01-AFC-4
CALIF ENERGY COMMISSION

May 7, 2001

Subject: East Altamont Energy Center Application for Certification
Data Adequacy Response Set 3

EAST ALTAMONT ENERGY CENTER DATA ADEQUACY RESPONSE SET 3

**Attachment TSE-2
Power Load Flow Diagrams**

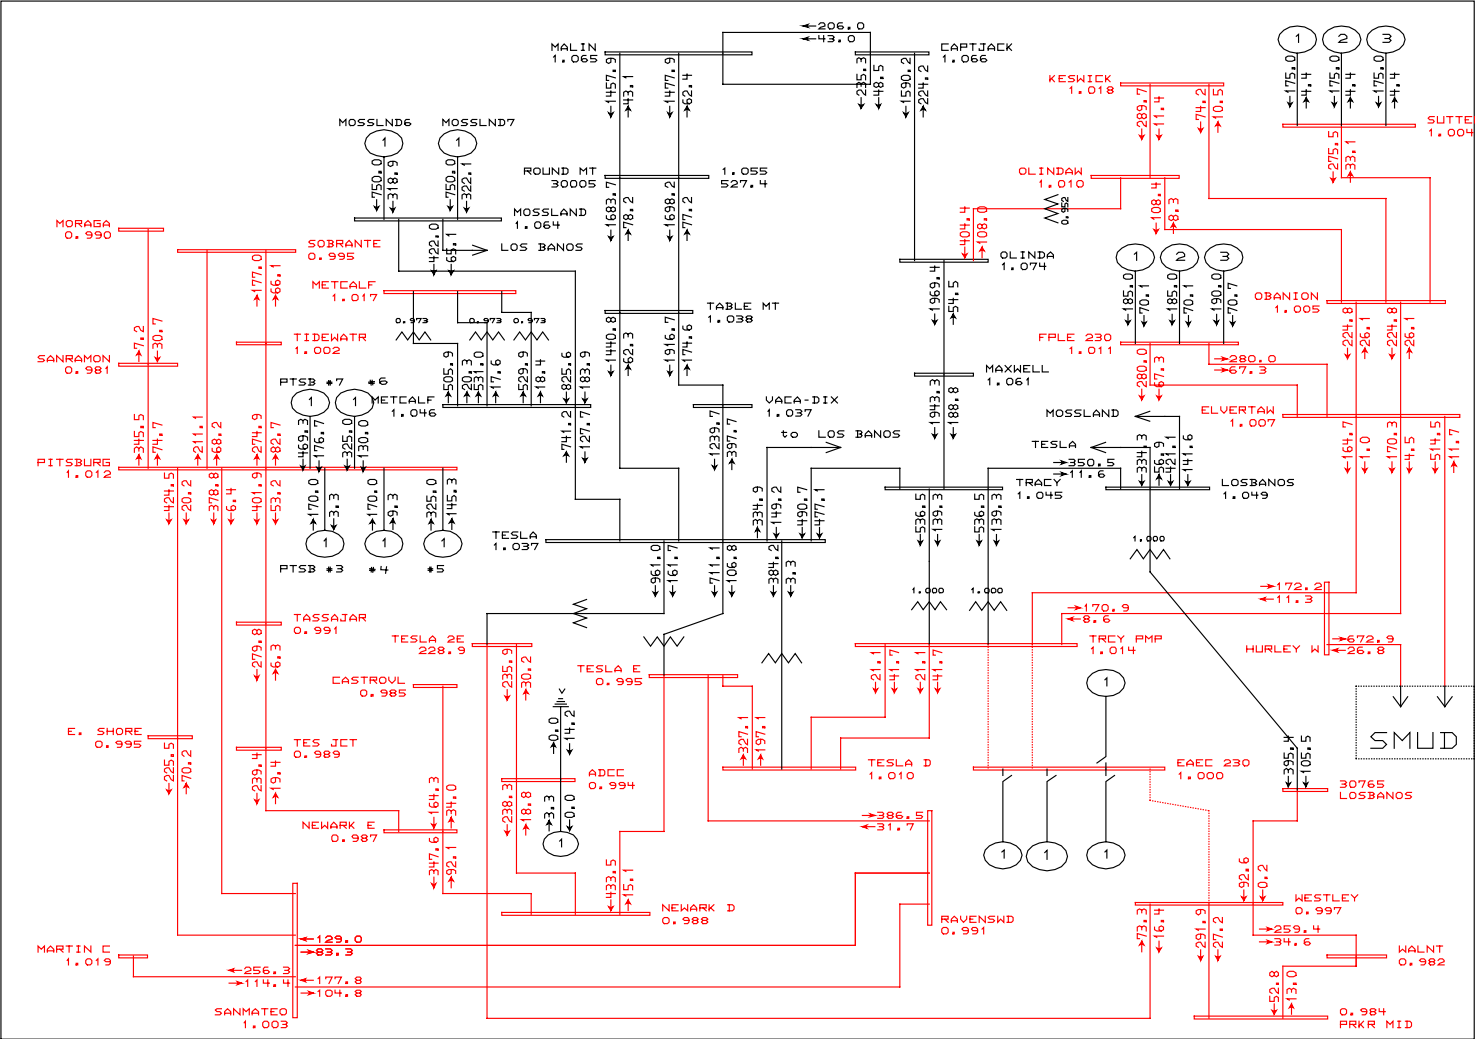
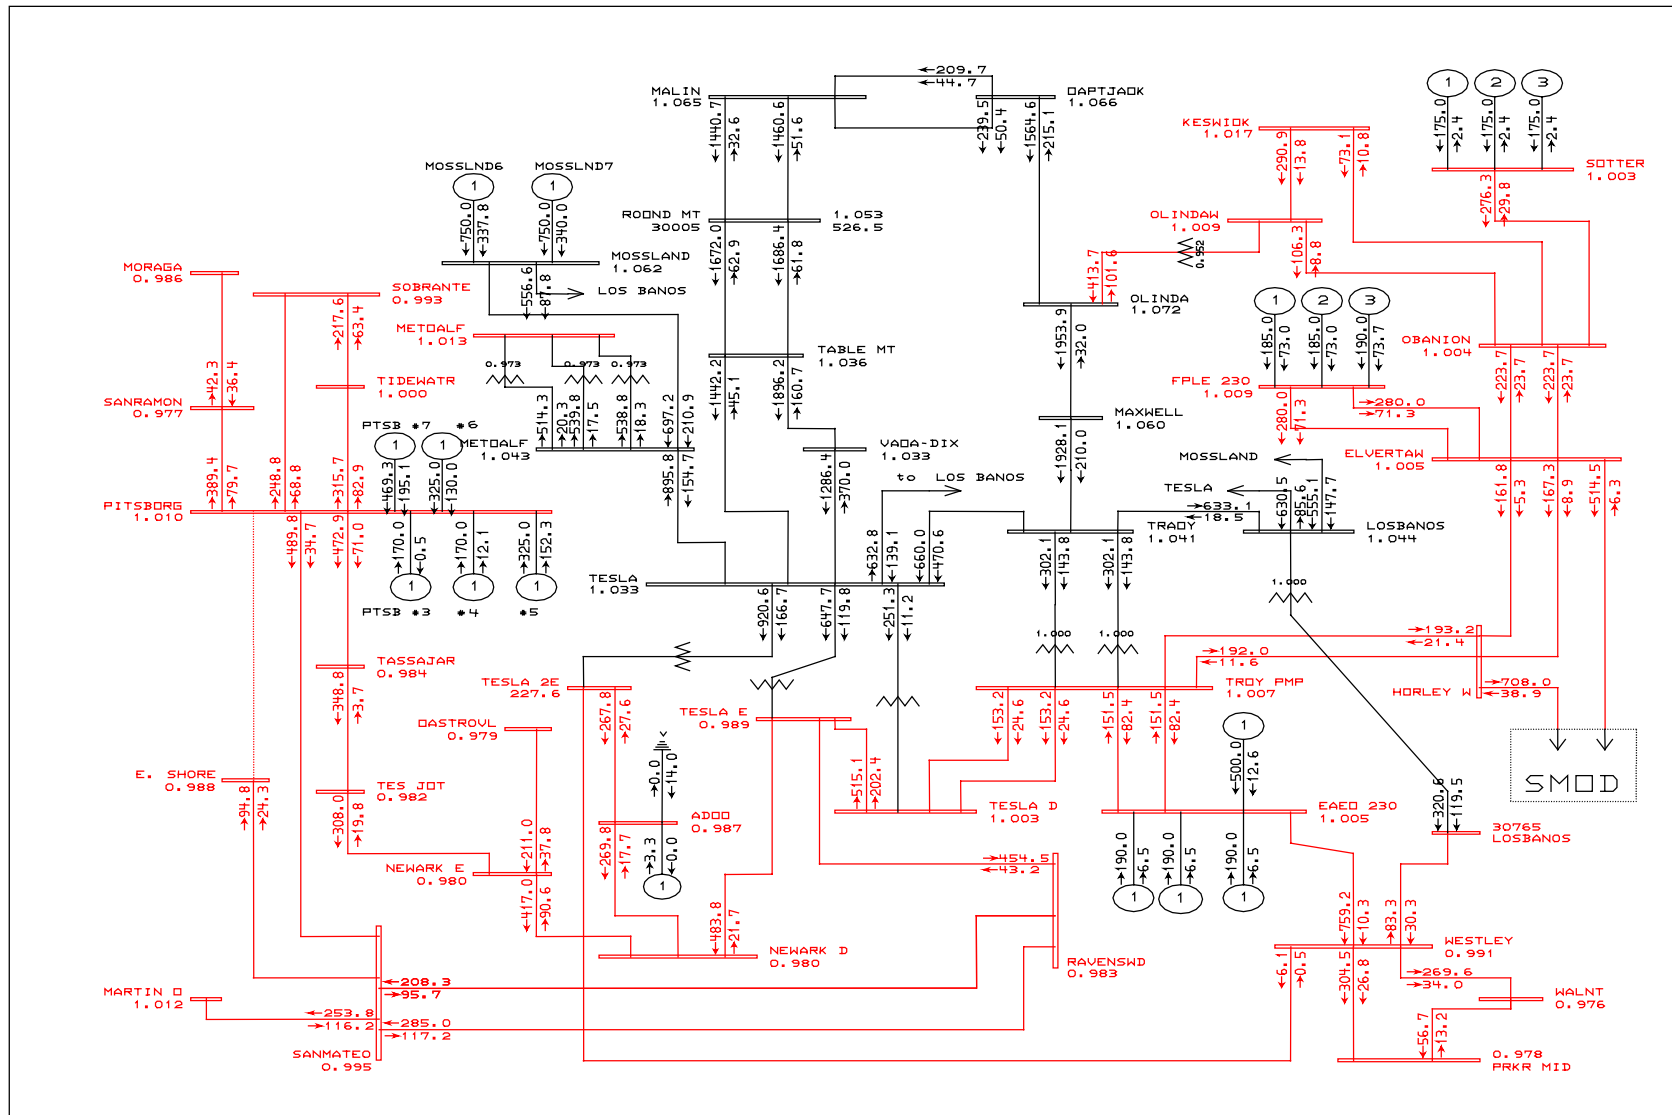
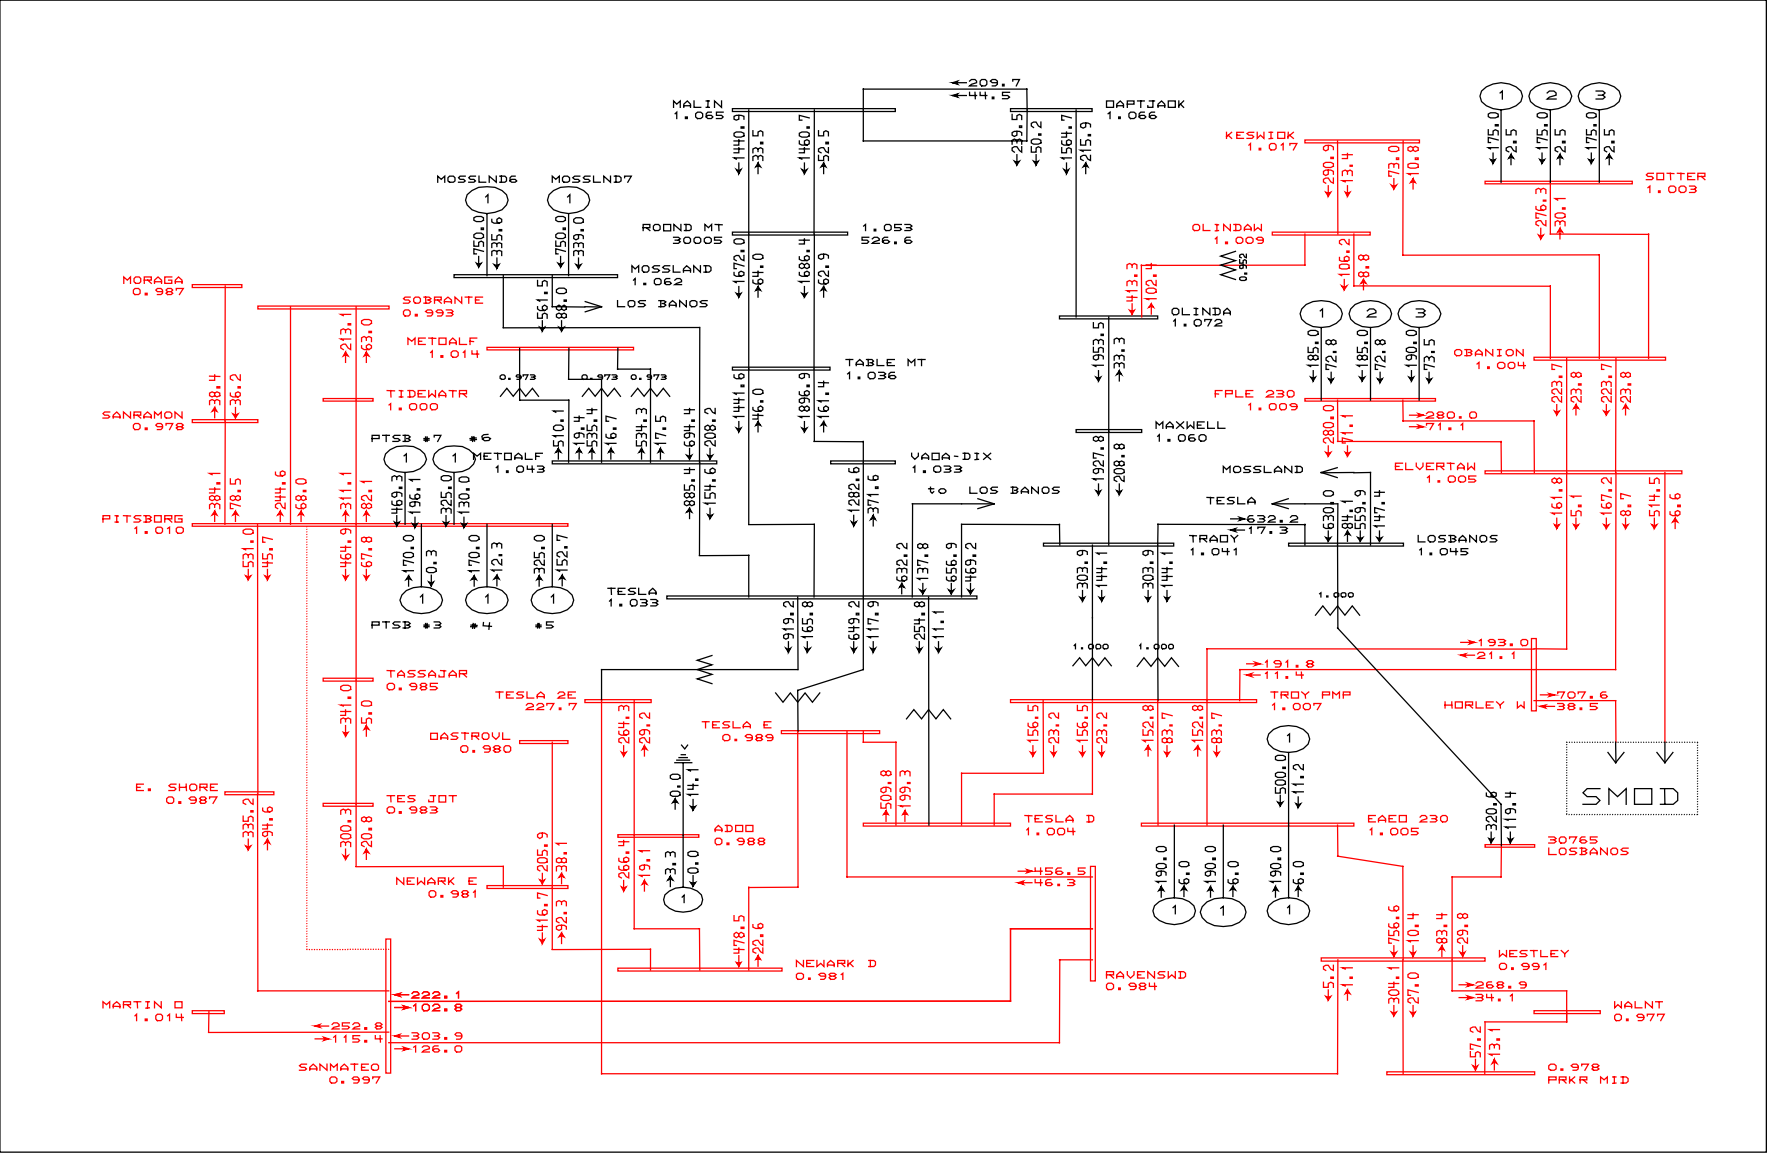
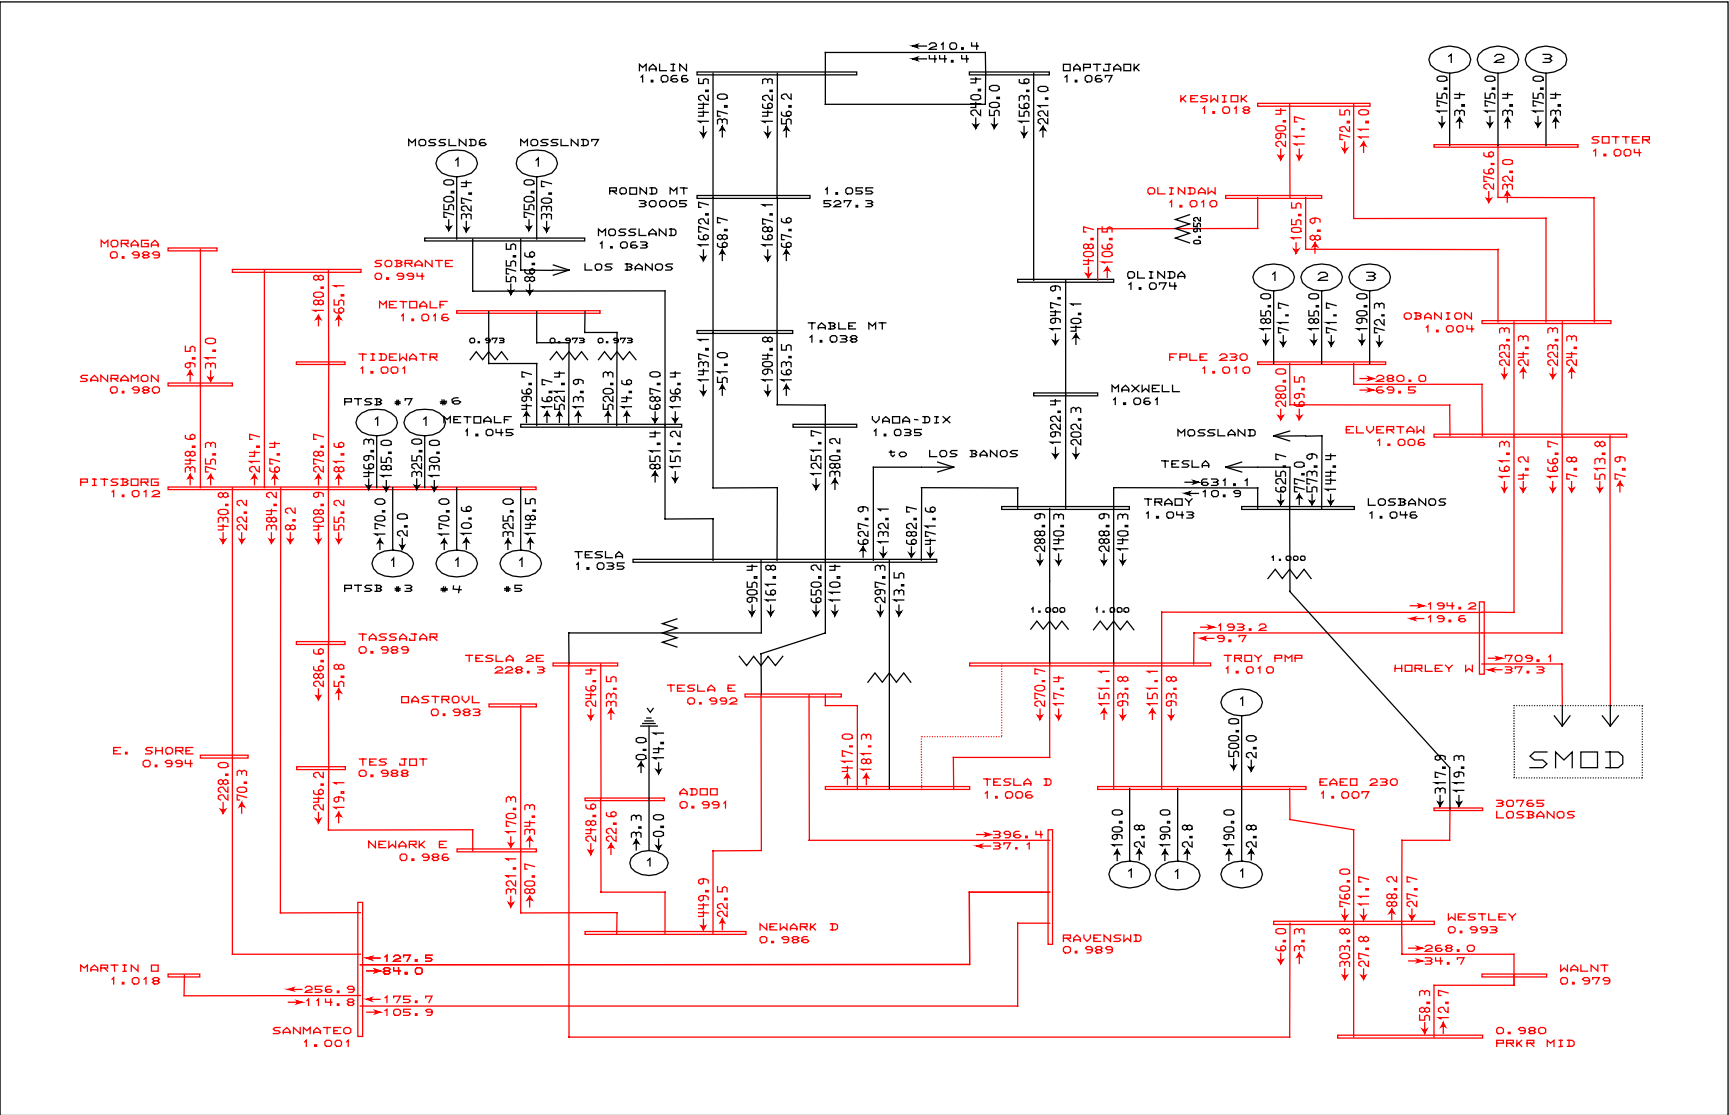
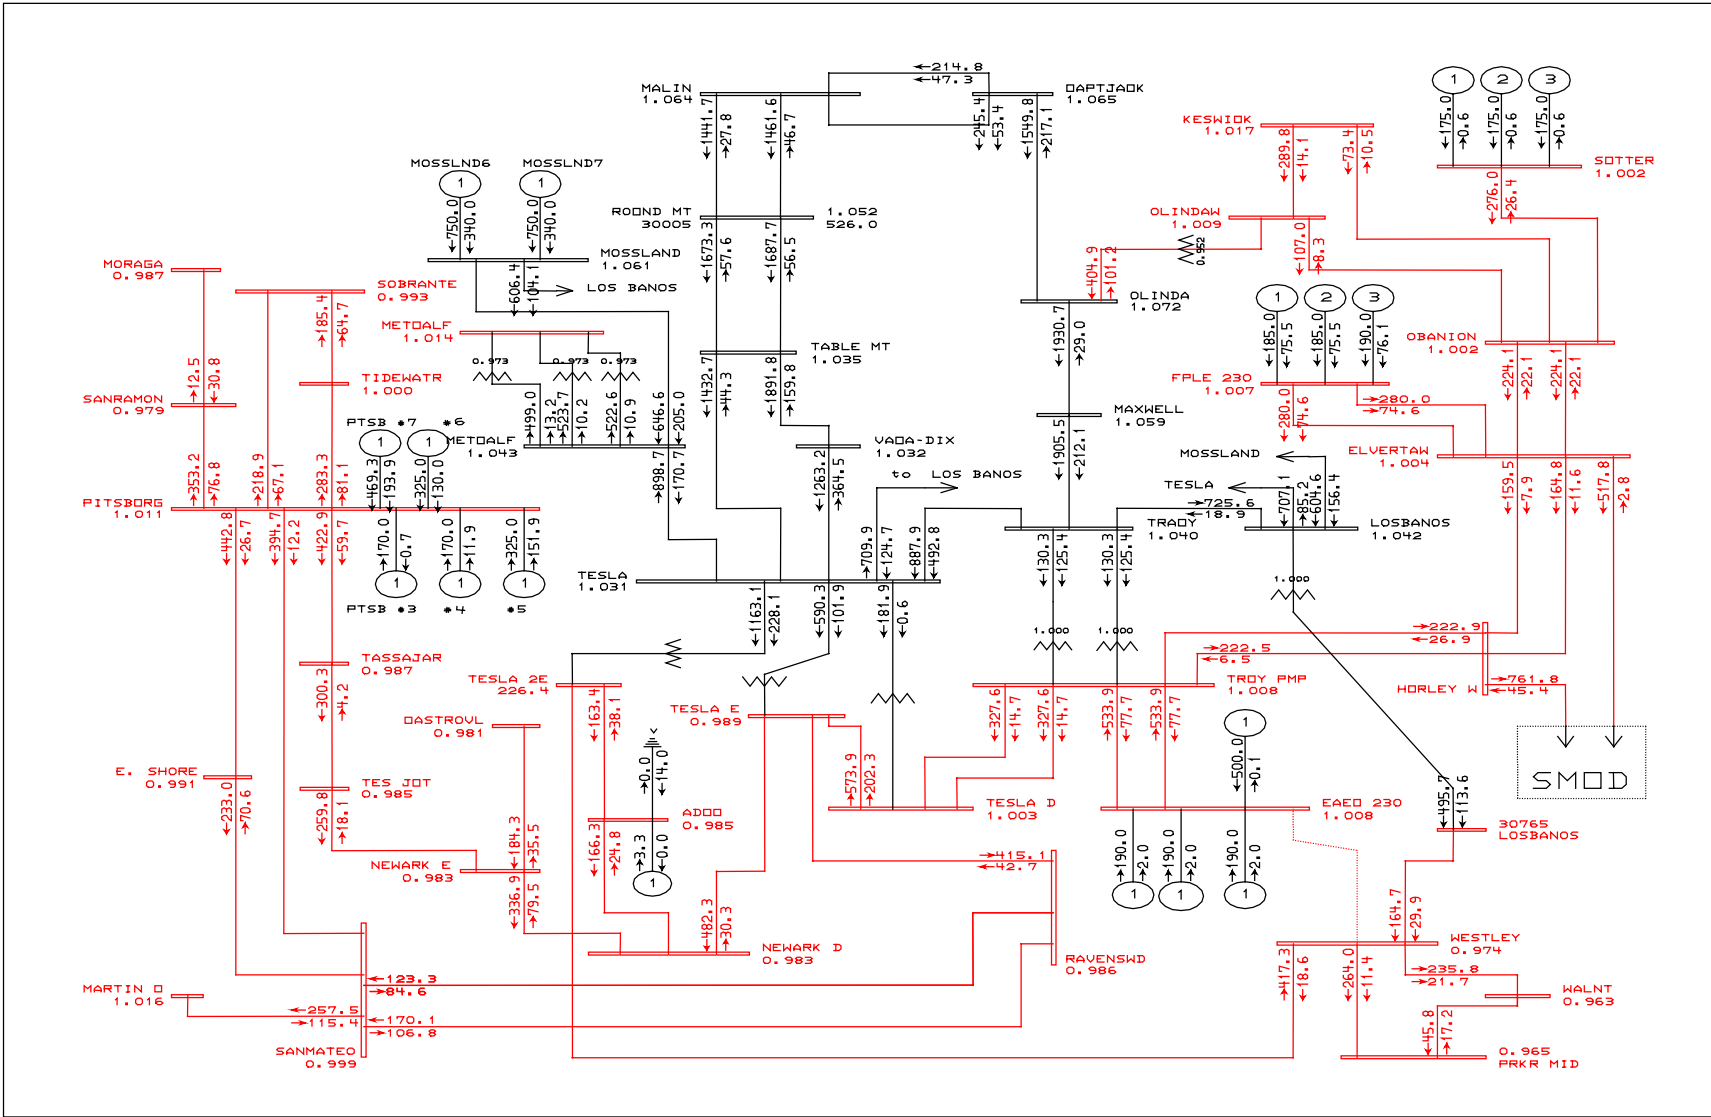
Data Adequacy Deficiency – Provide power load flow diagrams which demonstrate conformance or non conformance with utility reliability and planning criteria.

Provide a System Impact Study per the study plan of Appendix 5.4-A.

Data Adequacy Response – The power load flow diagrams prepared by Western Area Power Administration are attached as TSE-2. The attached power flow drawings are drawings of the base cases and the outages for each of the cases, which correspond to Tables 2, 3 and 4 in the System Impact Study submitted on May 2 in EAEC LLC's Data Adequacy Set 1.
